DART AEROSPACE LTD		Work Order: 155359
Description: Bar		Part Number: D3196-4
Inspection Dwg: D3196	Rev: C	Page 1 of 1

D3196-4 BAR

DRAWING NO. D3196	TITLE BAR	REV. C	DART AEROSPACE LTD ENGINEERING ORDER	D.E.O. NO. D3196-C-1	SHEET NO. SHEET 1 OF 2	SCALE NTS
DRAWN <i>ASS</i>	CHECKED <i>[Signature]</i>	MFG. APPR. <i>[Signature]</i>	APPROVED <i>[Signature]</i>	DE APPR. <i>[Signature]</i>		
DATE 08.08.27	DATE 08.08.28	DATE 08.08.29	DATE 08.08.29	DATE 08.09.04

D3196-1 BAR

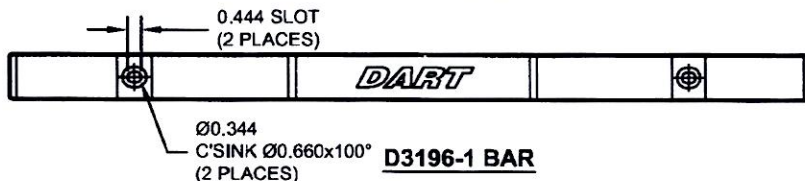
SHEET 1 MODIFY SLOT DIMENSIONING ON D3196-1 AS SHOWN:

D3196-3 BAR

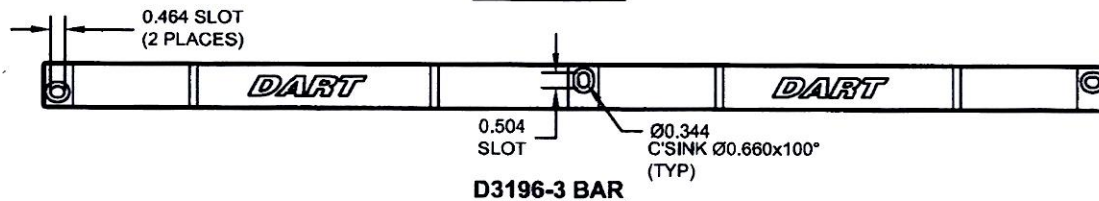
SHEET 2 MODIFY SLOT DIMENSIONING ON D3196-3 AS SHOWN:

D3196-4 BAR

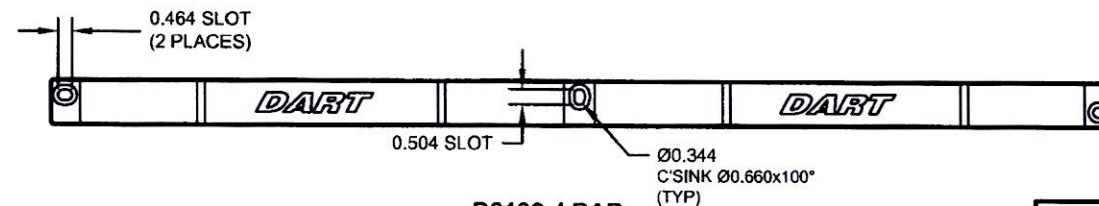
SHEET 3 MODIFY SLOT DIMENSIONING ON D3196-4 AS SHOWN:

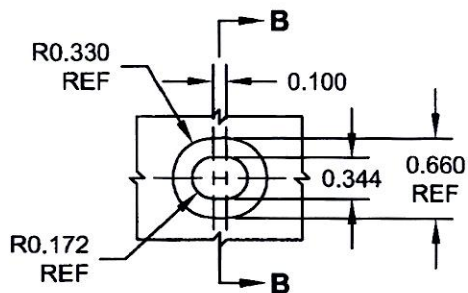
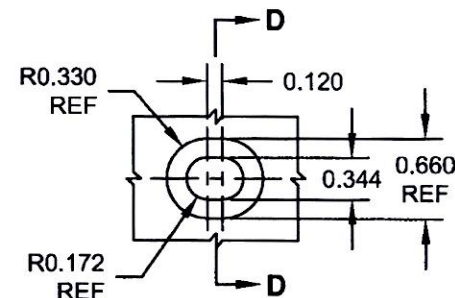
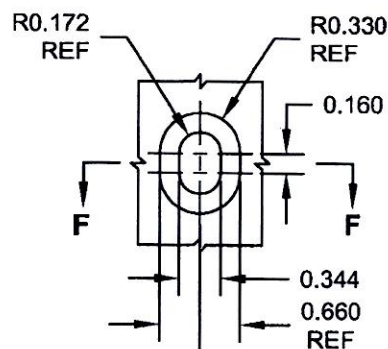
NOTE: THIS CHANGE HAS BEEN DONE TO CLARIFY SLOT DIMENSIONS ONLY. NO CHANGES HAVE BEEN MADE TO THE PARTS
SEE NCR 08-051 FOR FURTHER INFORMATION
ALL OTHER INFORMATION REMAINS UNCHANGED
